Development Committee

NORTH
NORFOLK
DISTRICT
COUNCIL

8. SHERINGHAM - PF/20/1564 - VARIATION OF CONDITION 2
(APPROVED PLANS) OF PLANNING PERMISSION PF/14/0887
(PARTIAL DEMOLITION OF HOTEL AND ERECTION OF SIX
RESIDENTIAL APARTMENTS AND SINGLE-STOREY REAR
EXTENSION TO HOTEL) TO AMEND THE DESIGN; FORMER
BURLINGTON HOTEL, THE ESPLANADE, SHERINGHAM FOR
JAEVEE SPV1003 LTD (Pages 41 - 94)

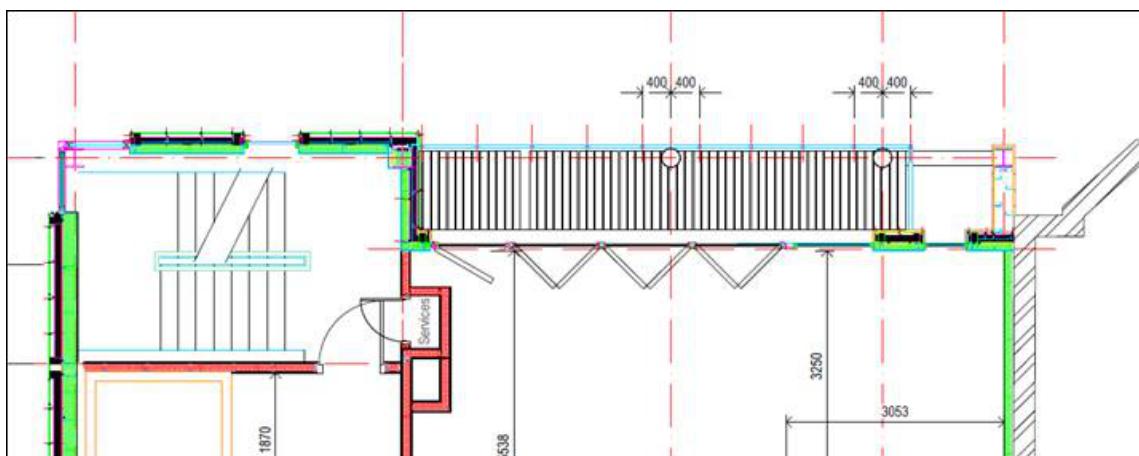
- As approved, the extension purposely featured an indented step back from the front corner of the existing building. This was to ensure it paid due deference to the host structure and so that it had some regard for the stone dressings which turned the corner onto the west-facing gable (NB: this happens on 4 separate occasions and not just at FF floor level as suggested in the agent's notes – see the white circles in the image below).
As proposed, however, the extension has effectively been pulled forward in its entirety and now shows a projecting wall springing out of this corner to meet a new steel corner post. Not only is this likely to see the loss, concealment and/or cutting through of these important string courses, but it will also result in the new build completely trumping the original hotel. On a point of detail, it is noted that this new corner post is shown faced in brick slips on the submitted elevation. However, the email below refers instead to circular powder coated flashing instead. Either way this alteration must be considered harmful.

- Similarly, the extension as approved made allowances for the decorative cornice which returns around the west gable under a small tiled roof. This was in recognition of the

importance of this feature in capping both the main elevation and the east-facing return (in which a similar detail can be seen). The second photo above shows this feature more clearly prior to its apparent removal.

As proposed, however, it would appear that this has been unceremoniously chopped off so that the steelwork can be driven past and out to meet the new corner post (see yellow circle in the image above). This alteration therefore has to be considered insensitive and harmful.

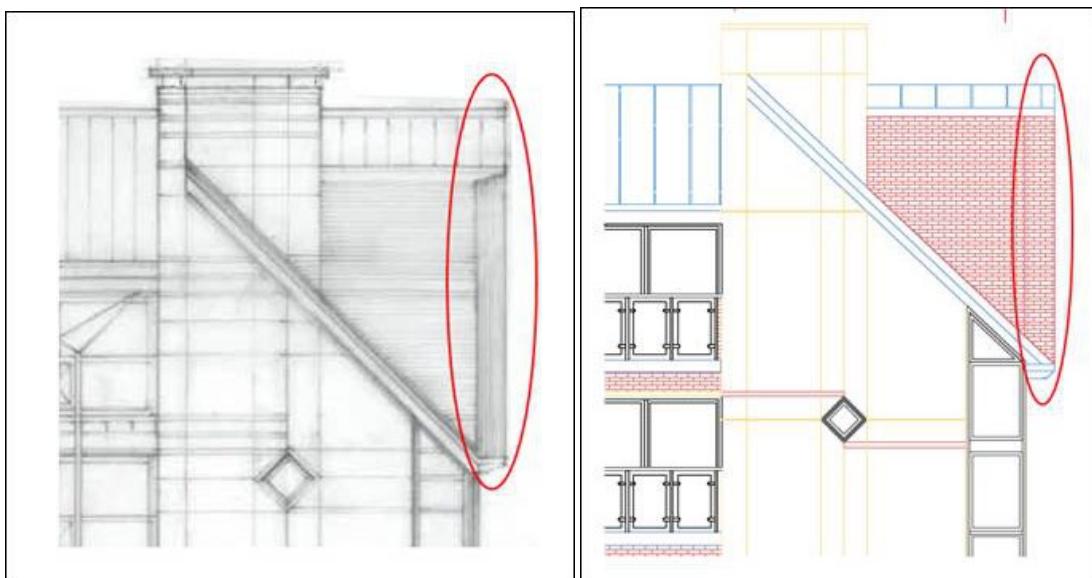
- * In offering this comment, C&D are rather less concerned about the changing position of the smaller square windows below which as approved did not obviously align with the existing building.*

- It is not entirely clear what is proposed in respect of the front lean-to canopy over the entrance. As proposed, it has been shown as a simple line on both the northern and western elevations which clearly cannot be the case. It is therefore assumed that the full extent of the lean-to has simply not been drawn on the northern elevation.
- The change of facing materials is something that C&D should perhaps touch upon. As approved, these primarily featured a polychromatic mix of modular terracotta panels. As now proposed, however, these have been replaced by brick slips and rainscreen panels. With an overtly contrasting result inevitable either way, however, C&D do not consider this change to be materially harmful (hence why the revised materials were approved as part of the previous condition discharge).

West Elevation

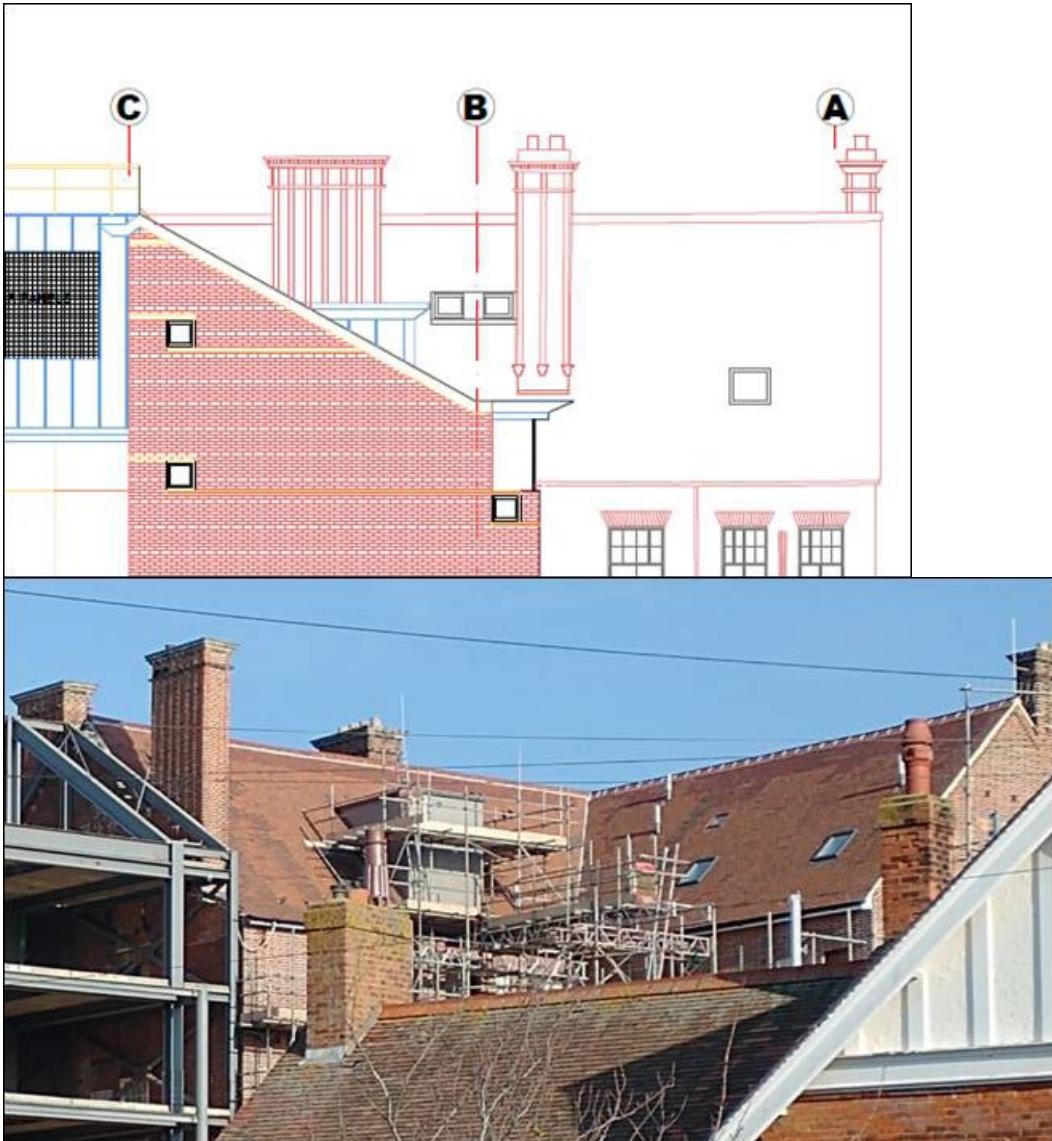
- As approved, the transition from the lift/stair tower to the accommodation was marked not only by a change of facing material but also by a change in the plane of the elevation. Not only did this reinforce the junction between the north and west-facing gables but it also added depth and interest to the elevation.

As proposed, however, the pitch of the roof has been slackened off to allow for the jacking up of the eaves at the back of the new build – the consequence would be a weightier and less elegant looking gable. It would also seemingly no longer have the overhanging verge detail (at least from what we can infer from the northern elevation – see before and after extracts below). Instead the indication is that it would only be capped with a less effective fascia board (unless the brick slip hatching has been wrongly applied).

- On another point of detail, this elevation shows two large chimneystacks on the existing

building. However, only that on the gable end still appears to be in situ. Whether the applicants have knocked the other one down is unclear. The configuration of rooflights on the existing building also appears to be inaccurate (see images below).

It is noted comments have been made regarding the second chimney on this elevation and we can advise that the approved drawings of permission PF/14/0887, in particular drawing 041A allowed for the demolition of the rear secondary chimney (west elevation) and which has been removed. Therefore, there is no proposal to reinstate this chimney, particularly in light of the structural difficulties to reinstate the chimney and the fact its removal was agreed as part of the previous approval.

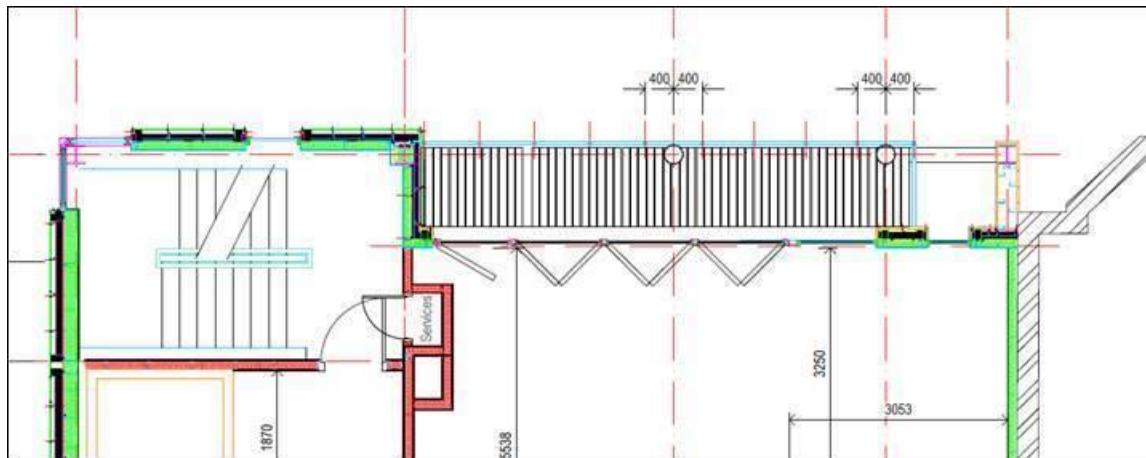
- Similarly, the extension as approved made allowances for the decorative cornice which returns around the west gable under a small tiled roof. This was in recognition of the importance of this feature in capping both the main elevation and the east-facing return (in which a similar detail can be seen). The second photo above shows this feature more clearly prior to its apparent removal.

As proposed, however, it would appear that this has been unceremoniously chopped off so that the steelwork can be driven past and out to meet the new corner post (see yellow circle in the image above). This alteration therefore has to be considered insensitive and harmful.

The latest information confirms that this eaves and cornice detail would be retained. Whilst on the face of it this is something that we should be able to welcome, there are two reasons why support cannot nicely be offered at the time of writing; i) it has already been removed and therefore cannot be retained – it would have to reinstated, and ii) the actual act of reinstatement would surely be impeded by the return steelwork and the diagonal bracing. Even if it can physically be put back, it would be set in behind the corner post and would therefore lose some of its impact.

In relation to the eaves and cornice detail, the enclosed plan drawing J100-ST-165 Rev J & 16 Rev K has been amended to show this detailing being reinstated, rather than the previously stated retained, and also shows the bracing removed, which ensures the corner post will remain a prominent architectural feature and will be fully visible behind the post.

West Elevation

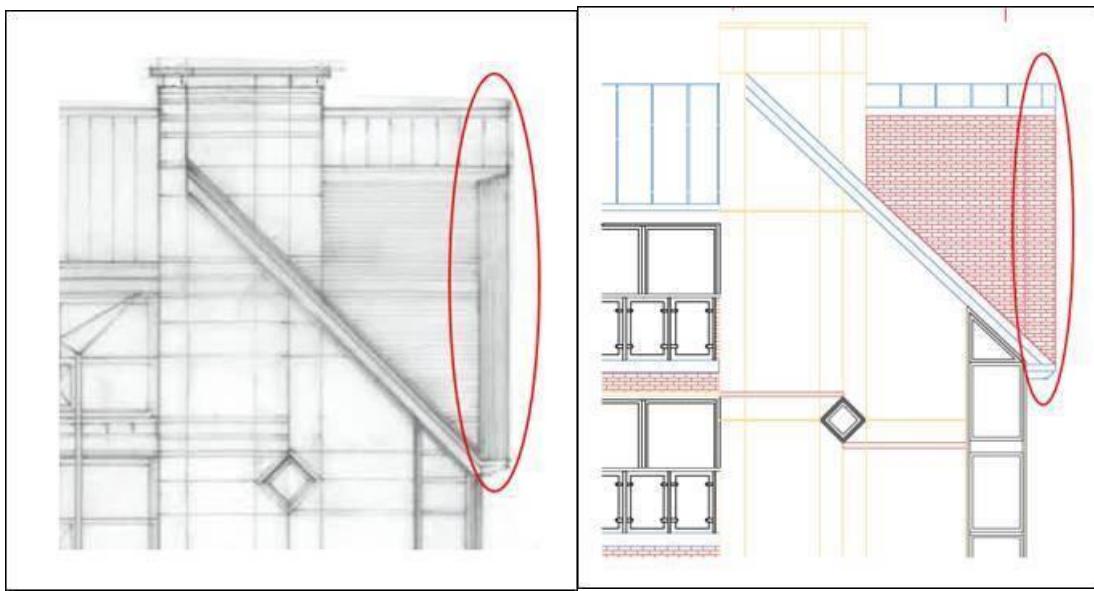
- As approved, the transition from the lift/stair tower to the accommodation was marked not only by a change of facing material but also by a change in the plane of the elevation. Not only did this reinforce the junction between the north and west-facing gables but it also added depth and interest to the elevation.

As proposed, however, this step would be removed and the two materials would be left to just run into each other with a flush butt joint. The net result would remove this important articulation and thus leave us with a comparatively flat and heavy looking elevation. It would also remove the ability to complete the feathered eaves line on the lift/stair tower.

The amended plans show the Trespa cladding being pulled 200mm out from the face of the brick slips. Whilst it is not clear how this would be done in practice (presumably some kind of projecting form/stud work), this is not critical from a planning point of view. More relevant is the fact that it would reinstate some much needed relief and a shadow line between the two materials. It therefore must be regarded as a positive move.

1. The area of Trespa Cladding on this elevation has been brought forward 200mm clear of the brick slip to provide the feature as required by the Approved drawings.
2. It is unclear on the approved drawing 1301/43A what is indicated at the junction with the west elevation at roof level. Both North and West elevations at this point are brick slip so the intention is that the corner would be formed in the same material.

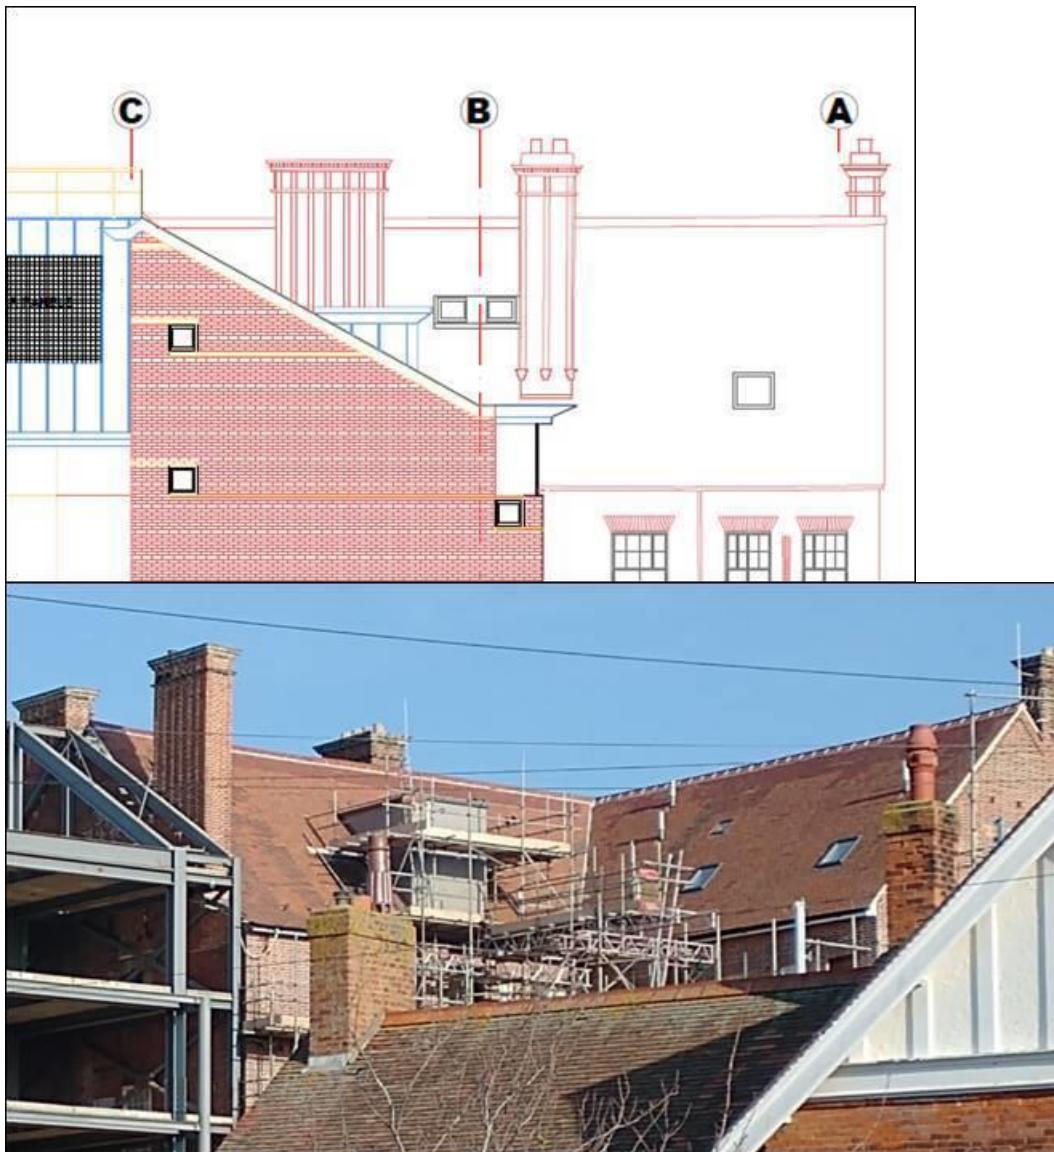
In-line with the North and South Elevations, the pitch of the roof remains unchanged. Hence, the previously expressed concerns about the gable still apply. As regards the overhanging verge detail, it is noted that the accompanying notes talk about *all* eaves and verges having a minimum 300mm overhang the soffit/fascia. Whilst this is a welcome confirmation, this unfortunately does not appear to have made its way onto the North Elevation. Instead, the brick slips annotation is still showing as finishing flush with the roof slope above. Therefore, unless the underside of the soffit is unusually also being faced with slips, something is missing. Additionally, it is not clear what the thin downpipe-like depiction is that has appeared in this area. If it is actually a downpipe, one might have expected it to have also featured on the West Elevation for clarity.

- On another point of detail, this elevation shows two large chimneystacks on the existing building. However, only that on the gable end still appears to be in situ. Whether the applicants have knocked the other one down is unclear. The configuration of rooflights on the existing building also appears to be inaccurate (see images below).
The configuration of rooflights has now been corrected but the absence of the second chimney on the proposed elevation appears to confirm that this has been taken down. Harm has therefore resulted from the loss of this important secondary stack.

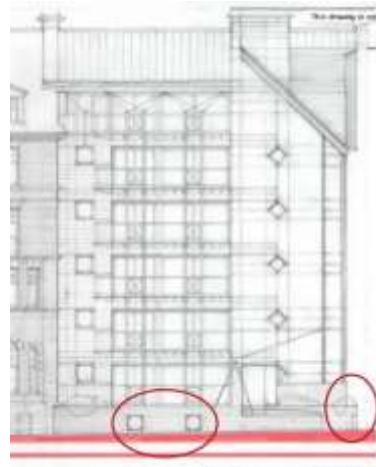
Particularly on the front elevation the extension would affectively ‘lead’ with its steelwork visually. Even if sections of this would be sheathed with curved aluminium profiles, the end result would still surely be a comparatively crude re-enactment of the original scheme. As approved, the skeleton would have remained silent and the balconies would have cantilevered gracefully out of the main elevation.

3. The new build would represent a less compatible version of that approved at high level.

The core of original scheme sought to echo the roof pitch of the core of the original building. In so doing, it would have not only obeyed one of the common ingredients of complementary design, but it would also have married up the main roof planes between existing and proposed. By contrast, the roof pitches front and back have been slackened as part of raising the main eaves line. The net result would inevitably mean the new build would ‘plug’ less successfully into, and would juxtapose more awkwardly with, the original hotel. It would also seemingly have consequences for the west elevation in terms of increasing its apparent width and bulk (even in its current skeletal form).
